Address
**34 FOUNTAINS AVENUE
SIMONSTONE**

drawing title
PROPOSED EXTERNAL ELEVATIONS

drawn by JL	date 17/03/26
scale 1:50 @ A1	Drawing no. revision 2026/04 A

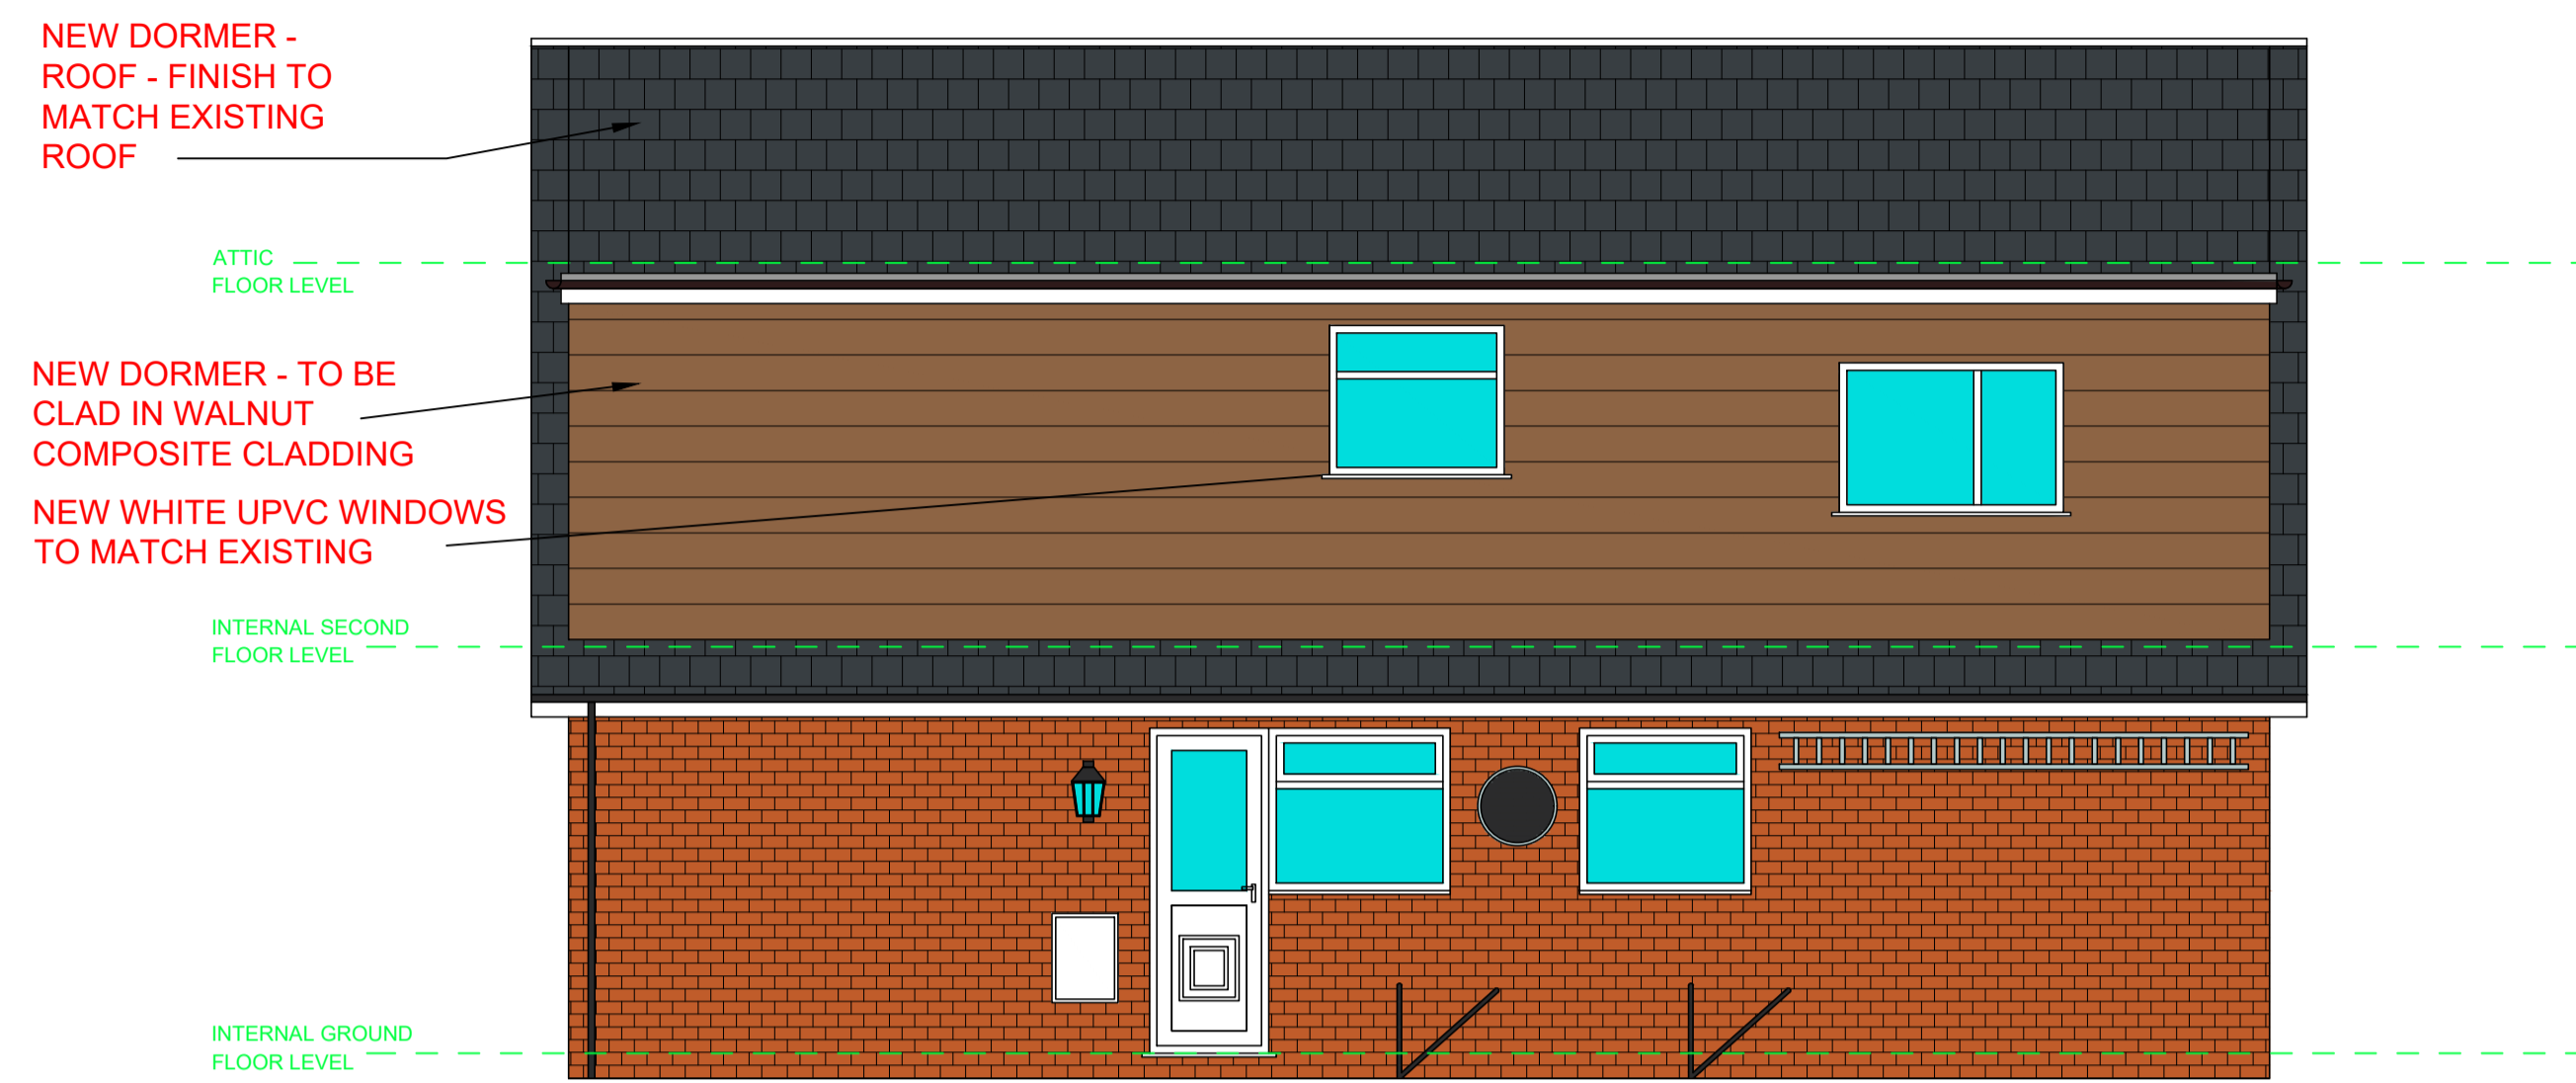
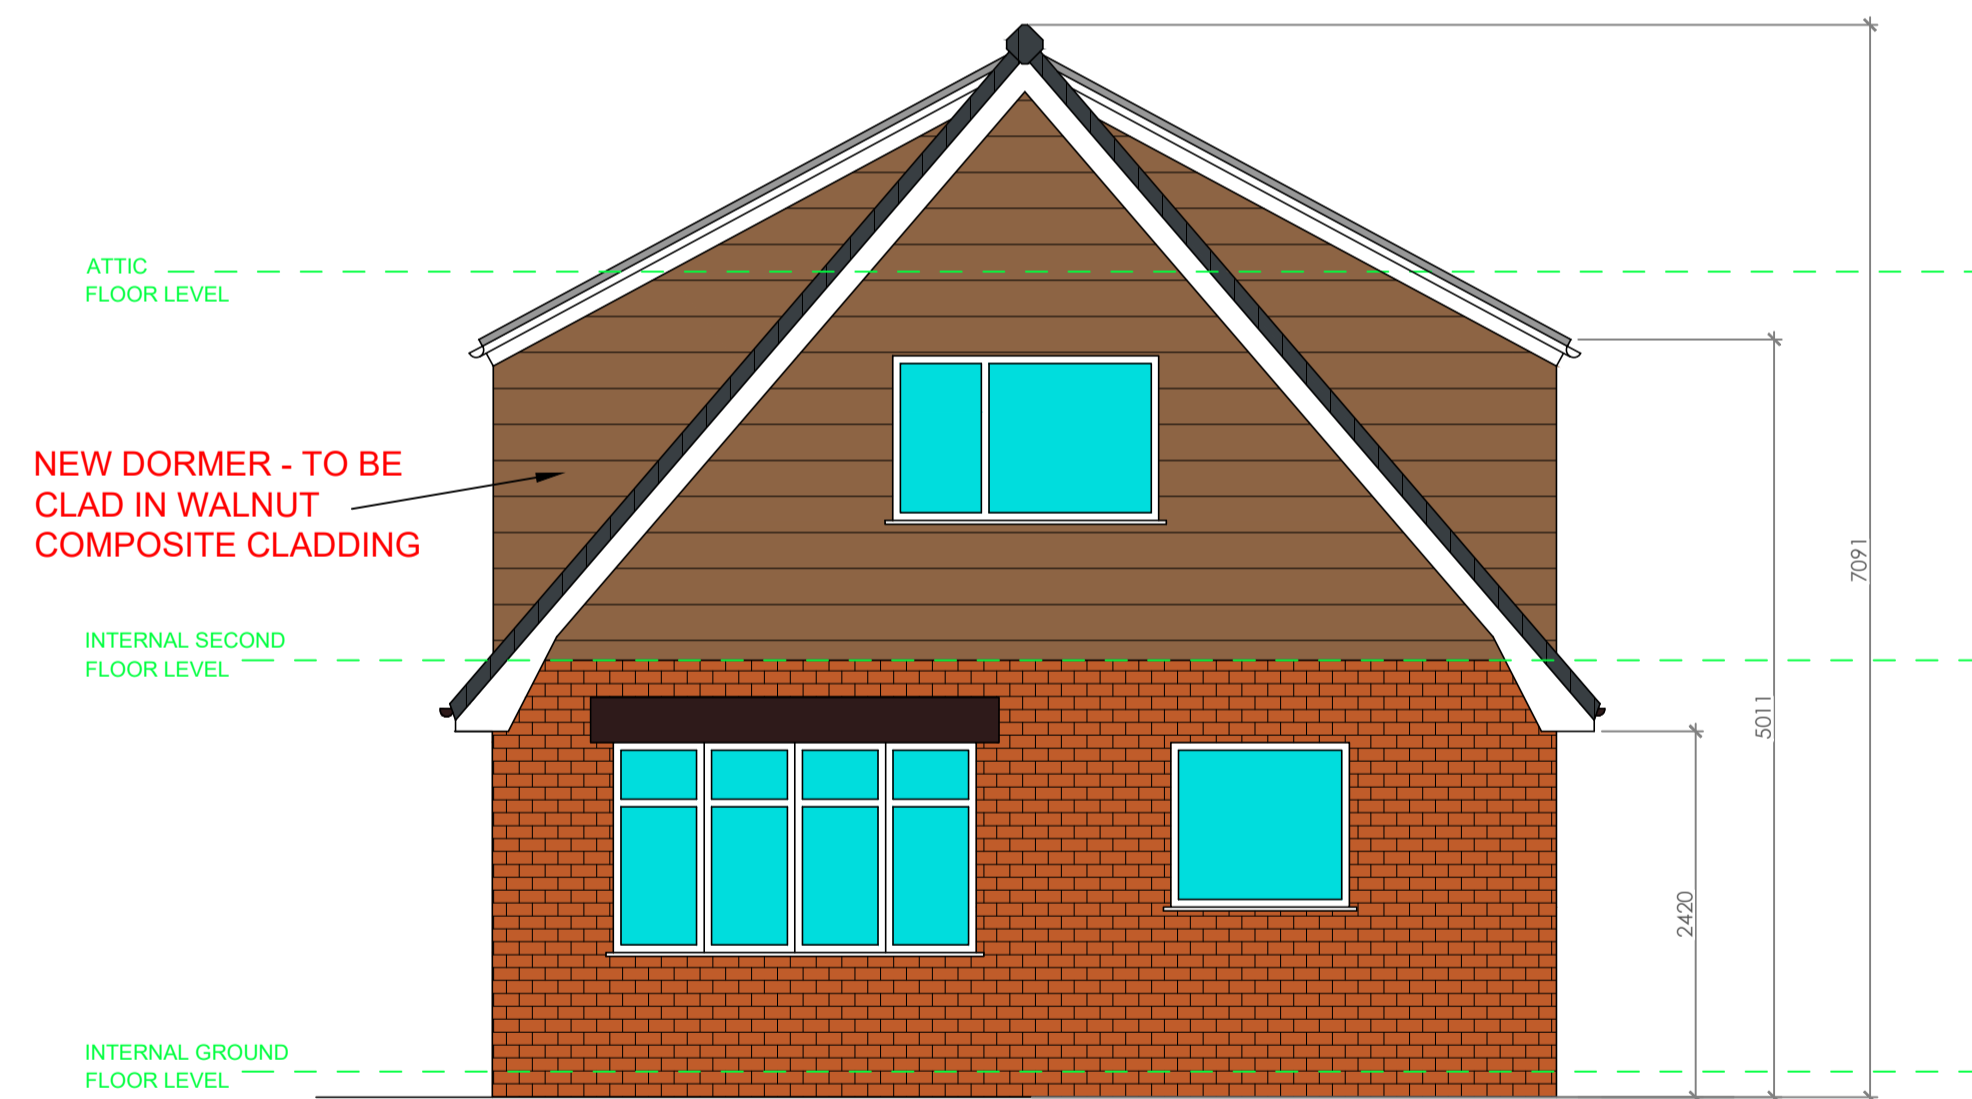
rev	date	description
A	28-04-26	Updated to suit clients comments: sky lights removed, windows increased to 1.5m wide, walnut composite cladding to dormer
